Interactive comment on “Use and uncertainty evaluation of a process-based model for assessing the methane budgets of global terrestrial ecosystems” by A. Ito and M. Inatomi

A. Ito and M. Inatomi

Received and published: 6 December 2011

Fig. 1. Revised Figure 3

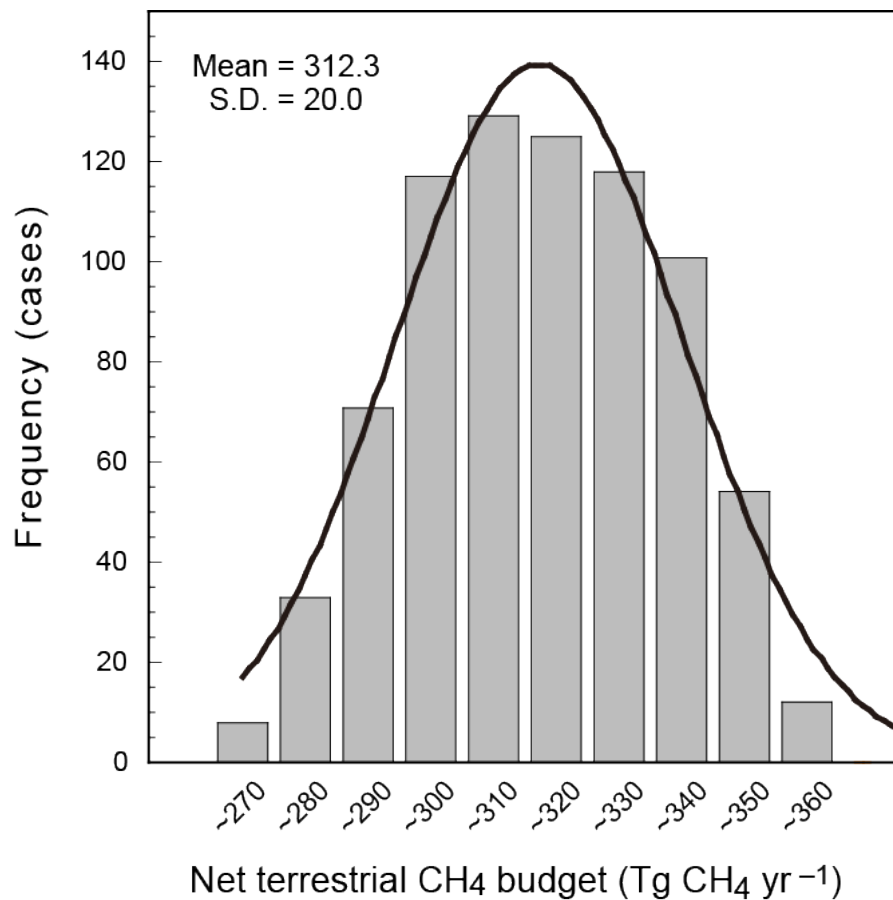
Comment: Although these studies use similar or sometimes exactly the same parametrisations of the emission/uptake processes, the global net CH₄ flux densities to the atmosphere are different in space and time (season, year). However, their total global emissions per year are very close to each other independent of their setup and parametrisations used. This implies that all studies somehow scale to the same global CH₄ emissions in order to be compatible with the atmospheric CH₄ budget inferred from top-down. I would thus argue that the different parameterisations (for wetland emissions at least), are not independent of each other. Thus my main criticism is that total CH₄ emission uncertainty and variability from bottom-up process based estimates are greatly underestimated and arguable larger than ± 18.9 Tg/yr as inferred for the calculated source total by Ito and Inatomi in this paper. Reply: We believe that two schemes of wetland CH₄ emission (i.e., Walter-Heimann scheme and Cao et al. scheme) were operated independently, at least in the present study. We note that the range of es-

timination actually spanned from min. 262 to max. 359 Tg CH₄ yr⁻¹ (cf. Figure 3); standard deviation, ± 20 Tg CH₄ yr⁻¹, is a metric of dispersion but does not represent the possible range. However, we agree that this study underestimate the true range of uncertainty, because (1) uncertainty in parameters (e.g., Q10 of methane production) was not fully addresses in this study, and (2) uncertainty in prognostic estimation of wetland area was not included in the present study. If these uncertainties were included, the range of terrestrial CH₄ budget should be enlarged. Evaluation of these factors is, however, beyond the scope of this paper and will remain for our next study. This limitation is explicitly discussed in the revised manuscript.
